HISTORIC AND DESIGN REVIEW COMMISSION October 16, 2019

HDRC CASE NO: 2019-582 ADDRESS: 1120 IOWA ST

TYPE OF WORK: Window replacement APPLICATION RECEIVED: September 27, 2019 November 26, 2019

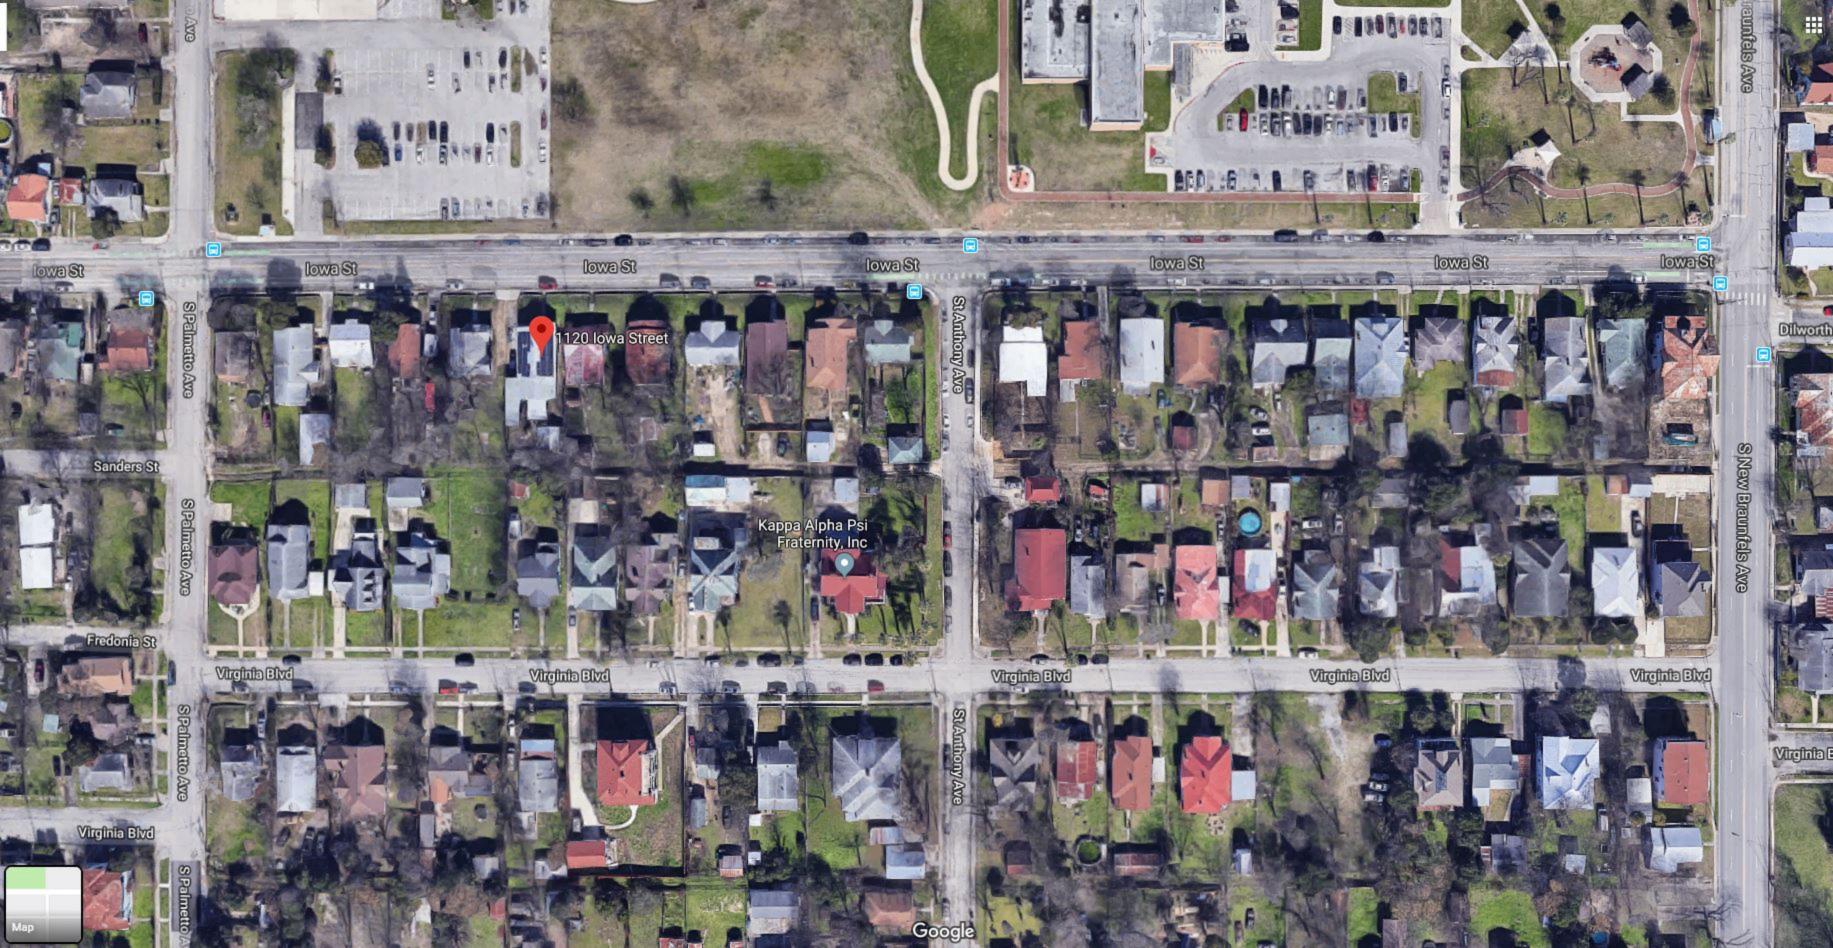
- e. WINDOW REMOVAL The applicant has proposed to remove and infill the set of ganged windows on the side elevation, closest to the front façade. Per the Guidelines for Exterior Maintenance and Alterations 6.A.i., existing window and door openings should be preserves and applicants should avoid filling in historic door or window openings. Staff finds the window openings to be original and should not be infilled.

Staff does not recommend approval of item #1, wood window replacement, nor item #2 window removal based on findings b through e. All wood windows should be repaired in-place. If the commission is compelled to approve window replacement, staff stipulates that the new windows should be wood instead of aluminum-clad wood with the standard specifications.

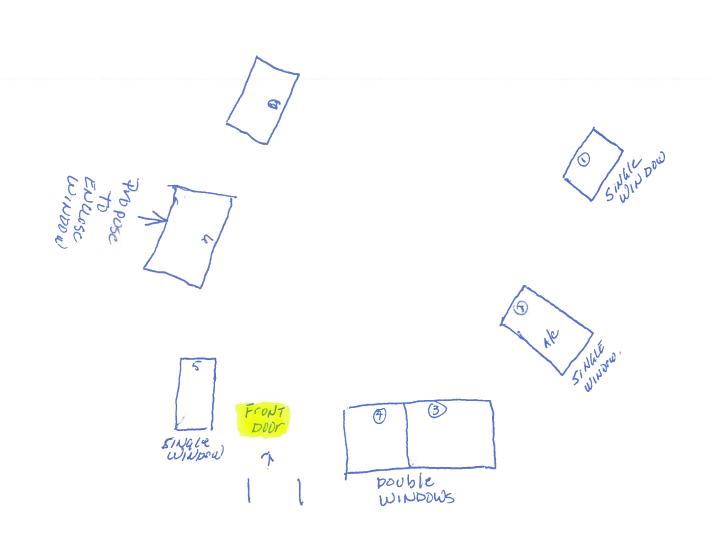
Propose to ENCLOSE WINDOW FrAME AND HAVE SIDINAPUT UP.
